**INTERPRETATION IC 90.1-2010-21 OF  
ANSI/ASHRAE/IES STANDARD 90.1-2010  
Energy Standard for Buildings Except Low-Rise Residential Buildings**

**Reference:** This request for interpretation refers to the requirements presented in ANSI/ASHRAE/IES Standard 90.1-2010, Section 6.5.2.2.1, relating to four-pipe common load systems.

**Figure 38. Four-Pipe Common Load System**

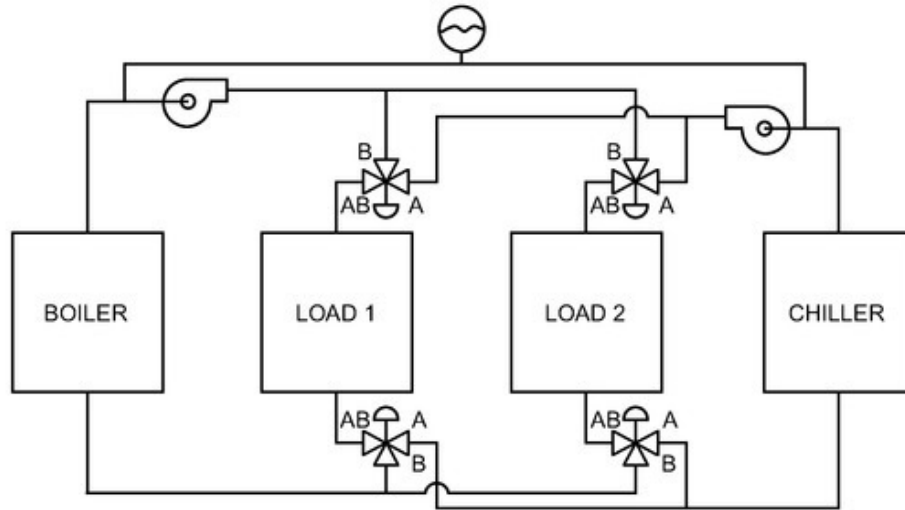
The design shown above is problematic but not because of valve leakage. Valve leakage causes energy waste even if separate heating and cooling coils are used.

If one of the coil valves in the design above was a modulating valve, then mixing of HW and CHW would occur and the return pipe that connects to the coil would be a “common return”, which is prohibited by Section 6.5.2.2 and 6.5.2.2.1. However, the design above would meet Section 6.5.2.2 if all the valves are two-position and controlled to simultaneously flip to connect the appropriate system, i.e. hot water supply to hot water return and chilled water supply to chilled water return. Nothing in Section 6.5.2.2 precludes this design since hot and chilled water are not substantively mixed. (The residual water in the coil will cause some energy waste but no more than if there were separate hot and chilled coils that were individually sequenced; in both cases, the water left in the coils must be reheated or recooled by the other system). However, with two-position valves, the system would then not meet 6.4.3.1.2 Dead Band requirements because the coil will always be heating or cooling and not able to provide a deadband where neither is provided.

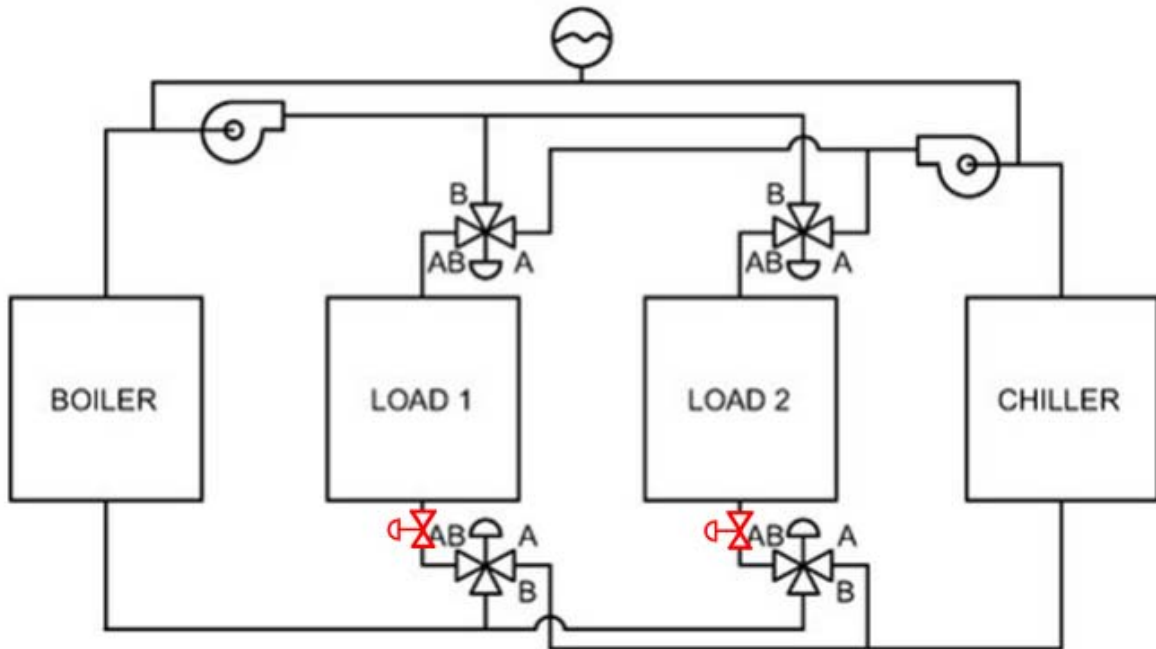
If two-way control valves were added to the design as shown below in red and if the 3-way valves are two-position, the design would meet Standard 90.1. (Three-way valves could also be used where allowed by 6.5.4.2 Hydronic Variable Flow Systems.)

In summary, Section 6.5.2.2 does not preclude using one heat exchanger, such as a coil, a radiant panel, or a radiant slab, for both heating and cooling providing that the design does not cause deliberate mixing of water between the two systems.
